HISTORIC AND DESIGN REVIEW COMMISSION

HDRC CASE NO: 2020-314
ADDRESS: 246 W MANDALAY DR
LEGAL DESCRIPTION: NCB 9012 BLK 6 LOT 25 26, 27, 28 AND 29
ZONING: R-4,H
CITY COUNCIL DIST.: 1
DISTRICT: Olmos Park Terrace Historic District
APPLICANT: Marlene Trevino
OWNER: UNKNOWN
TYPE OF WORK: Garage alterations
APPLICATION RECEIVED: June 25, 2020
60-DAY REVIEW: Not applicable due to City Council Emergency Orders
CASE MANAGER: Stephanie Phillips

The applicant is requesting a Certificate of Appropriateness for approval to modify the front fenestration of an existing accessory structure, to include the removal of two garage doors and installation of windows.

PLANNED UPDATES

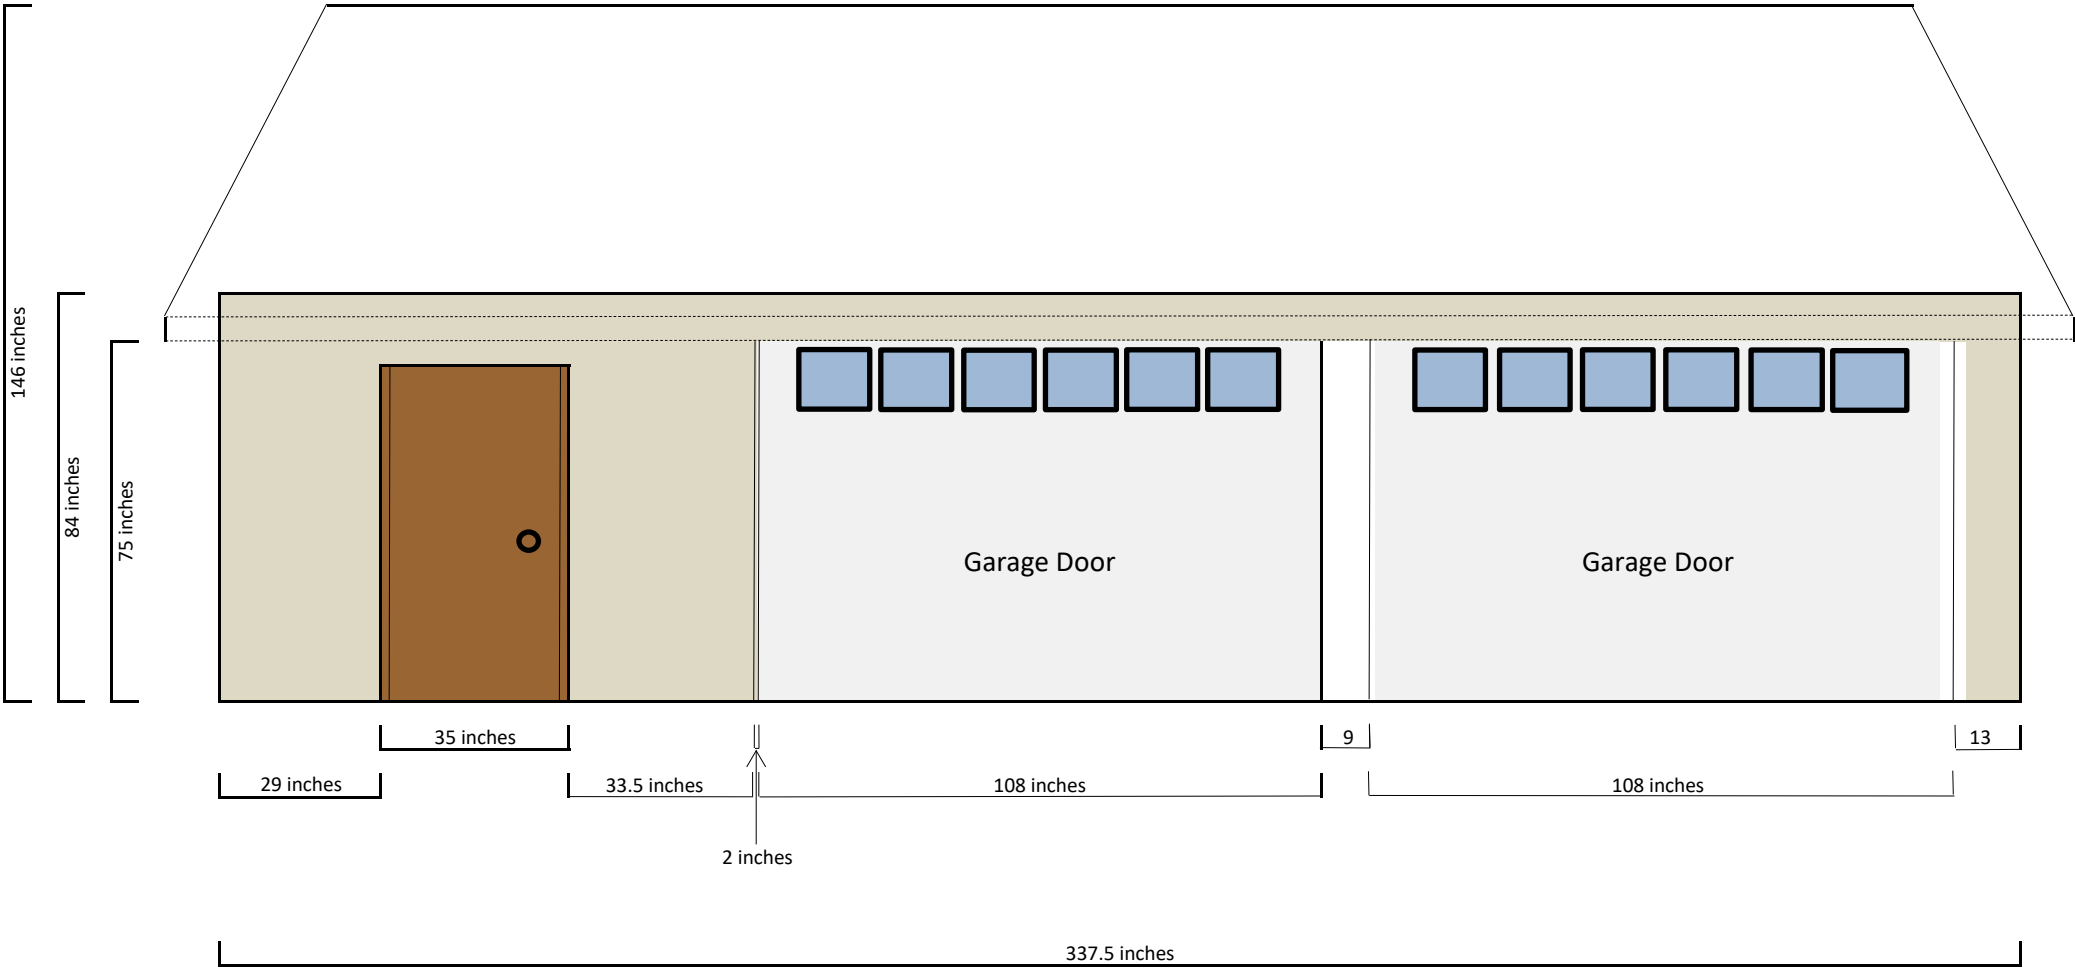
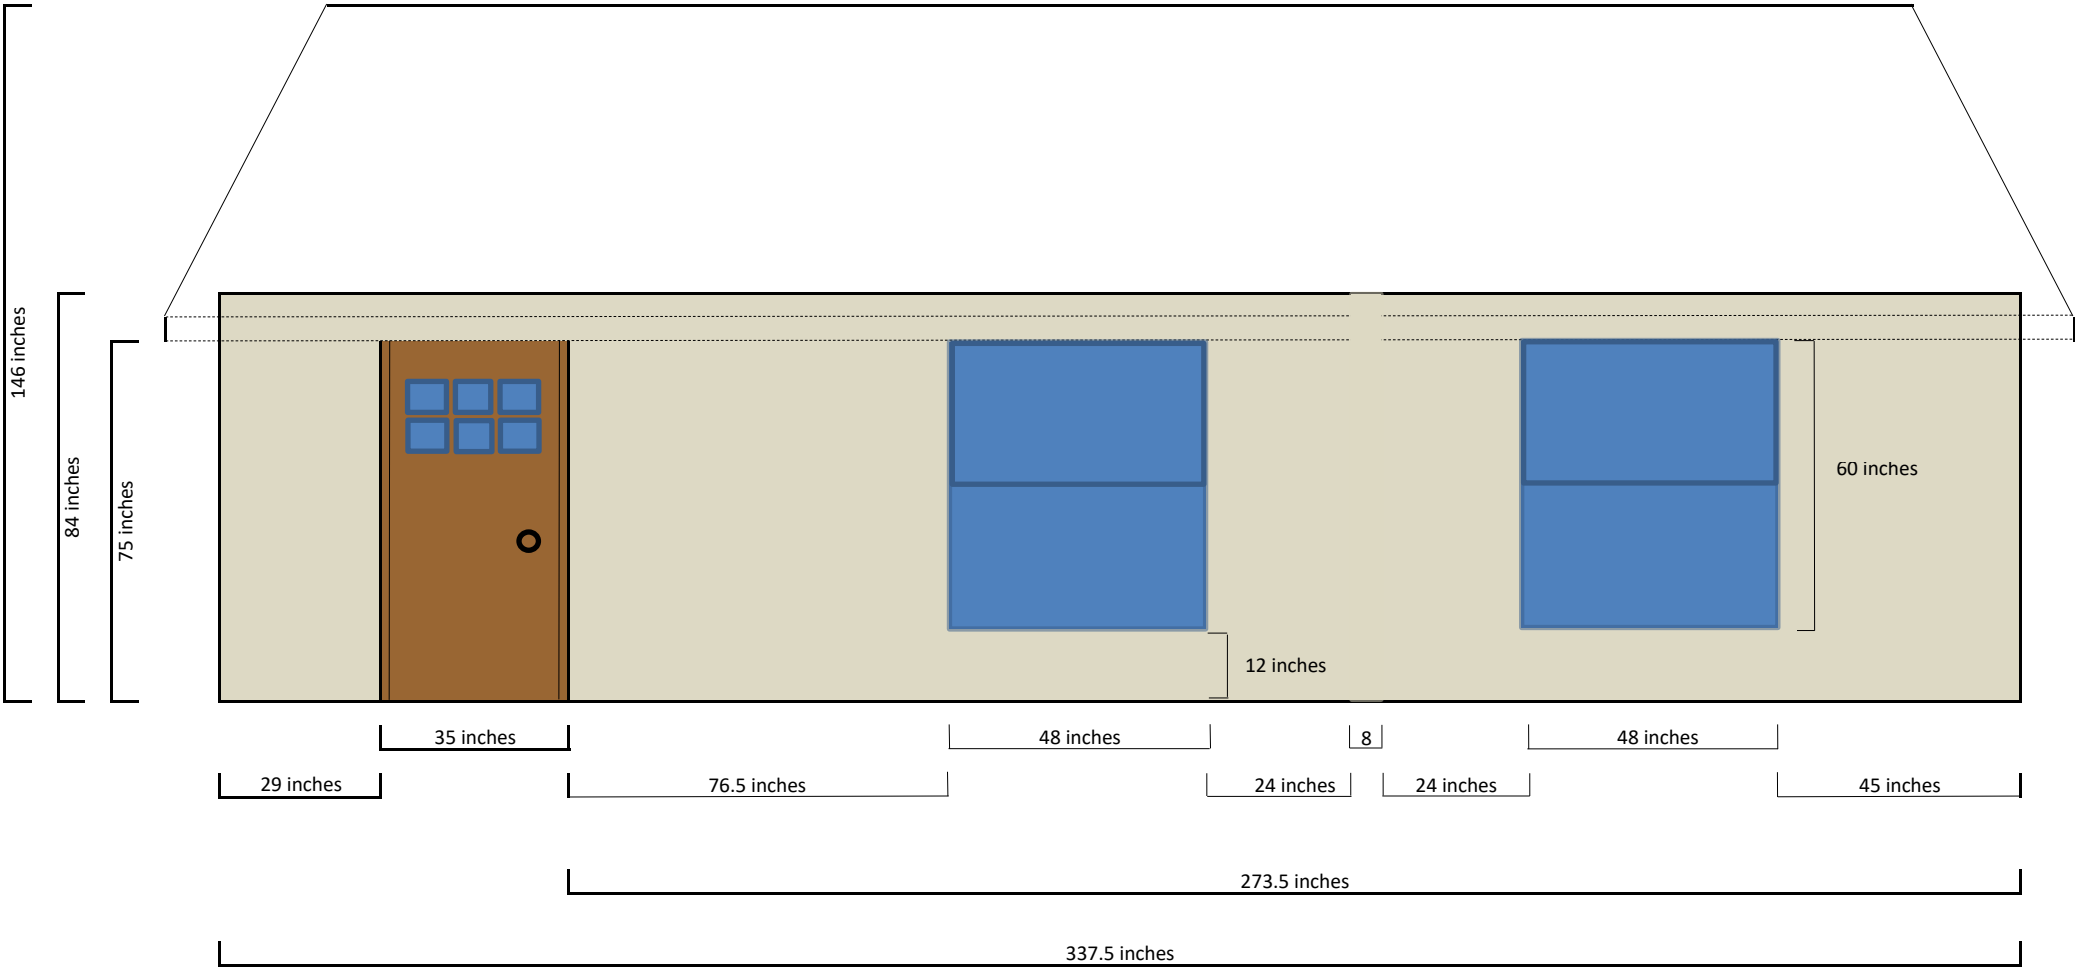
- b. FENESTRATION MODIFICATIONS – The applicant has proposed to remove two existing garage doors on the accessory structure and install new windows. The remaining space will be infilled with limestone to closely match the existing façade materiality. The new windows will feature a one over one configuration. As noted in finding a, the accessory structure is not original to the date of construction of the primary structure. The property is also unique in its double-wide configuration, and the primary structure features an attached single-bay garage, which is consistent with the historic development pattern of the district. Based on these site-specific considerations and the complementary nature of the proposed modifications, staff finds the request appropriate, but requires additional material information prior to the issuance of a Certificate of Appropriateness.

- i. That the applicant submits final specifications for the proposed one over one wood or aluminum clad wood windows prior to the issuance of a Certificate of Appropriateness that meet the following stipulations: meeting rails must be no taller than 1.25” and stiles no wider than 2.25”. White manufacturer’s color is not allowed, and window color should be presented to staff. There should be a minimum of two inches in depth between the front face of the window trim and the front face of the top window sash. This must be accomplished by recessing the window sufficiently within the opening or with the installation of additional window trim to add thickness. Window trim must feature traditional dimensions and architecturally appropriate sill detail. Window track components must be painted to match the window trim or concealed by a wood window screen set within the opening. Full vinyl or aluminum windows are not appropriate.

- ii. That applicant submits a final specification for the proposed limestone façade infill prior to the issuance of a Certificate of Appropriateness.
